# Work Order ID 86824

Item Name: Basket Hoop

DRAWING NO. D3166	TITLE BASKET HOOP	REV A1	DART AEROSPACE LTD ENGINEERING ORDER		D.E.O. NO. D3166-A-2	SHEET NO. 1 OF 1	SCALE NTS
DRAWN AJS	CHECKED J	MFG. APPR. M	APPROVED MD		DE APPR. H		
DATE 08.12.11	DATE 08.12.15	DATE 08/12/15	DATE 08/12/16		DATE 08.12.16

D3166-1 BASKET HOOP

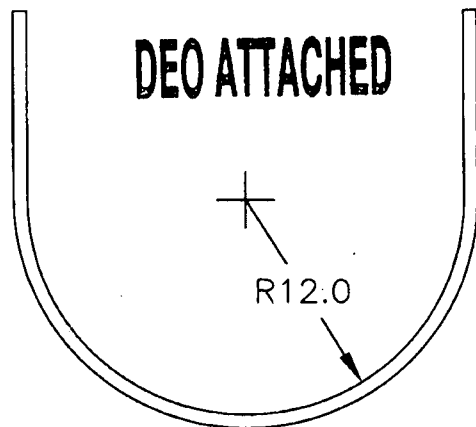
10.6 (REF, NEED 8.0 MIN)

1) MODIFY MATERIAL NOTE FOR D3166-1 AS SHOWN:

IS:

1) MATERIAL: AISI 304/316 SS, 3/4 X 3/4 X 0.065 WALL SQUARE TUBING,  
60.00" LONG  
REF. DART SPEC M304TS0.750W.065

WAS:

1) MATERIAL: AISI 304/316 SS SQUARE TUBING,  
0.75" x 0.75" x 0.063 WALL, 60.00" LONG  
(REF DART SPEC. M304TS0.750W.063)

D3166-3 BASKET HOOP

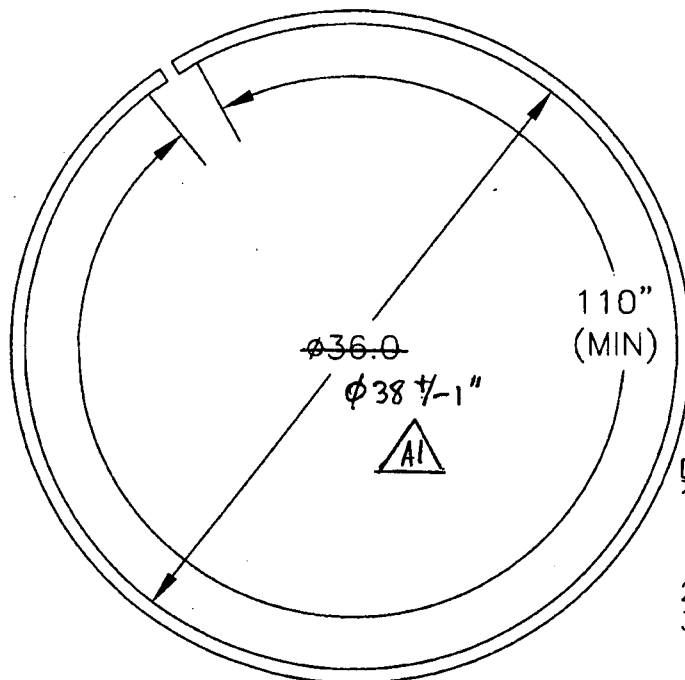
2) MODIFY MATERIAL NOTE FOR D3166-3 AS SHOWN:

IS:

1) MATERIAL: AISI 304/316 SS, 3/4 X 3/4 X 0.065 WALL SQUARE TUBING,  
120.00" LONG  
REF. DART SPEC M304TS0.750W.065

WAS:

1) MATERIAL: AISI 304/316 SS SQUARE TUBING,  
0.75" x 0.75" x 0.063 WALL, 120.00" LONG  
(REF DART SPEC. M304TS0.750W.063)
